Discharge Pump Handle Assembly - Baby Blake

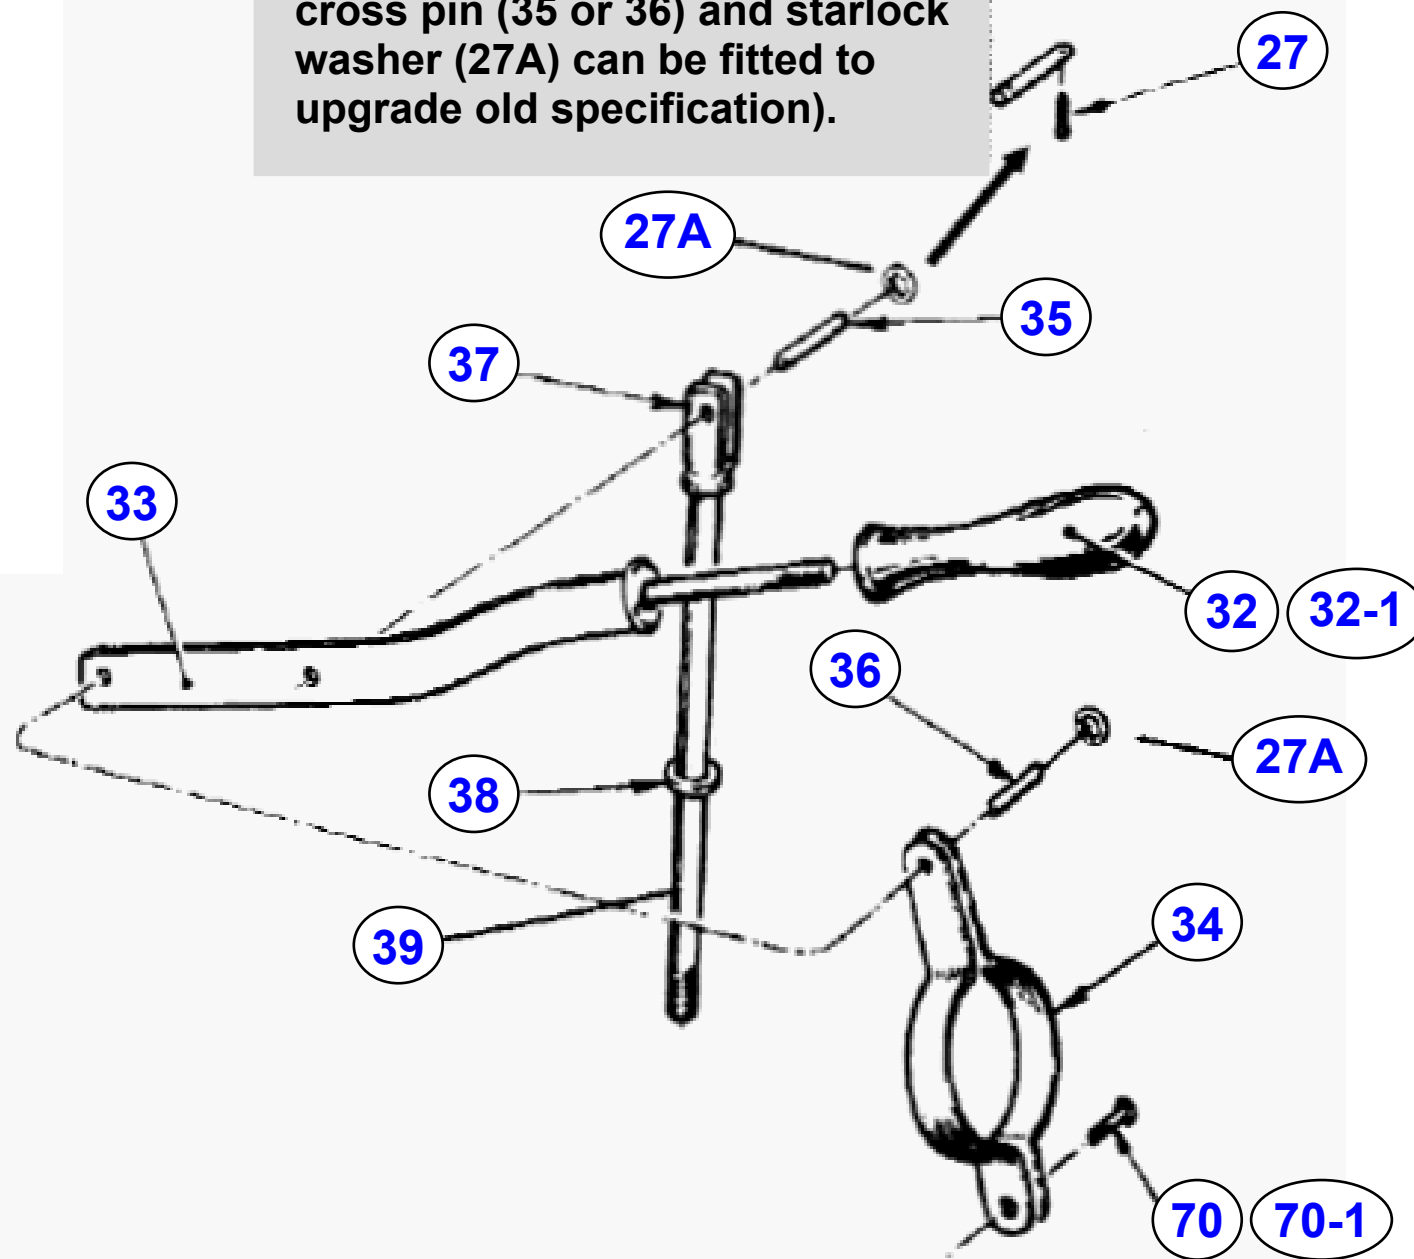
Note:
The option for a vertical handle has been discontinued as it caused adverse wear on the pump top seal

Old specification: split pin (current specification: undrilled cross pin (35 or 36) and starlock washer (27A) can be fitted to upgrade old specification).
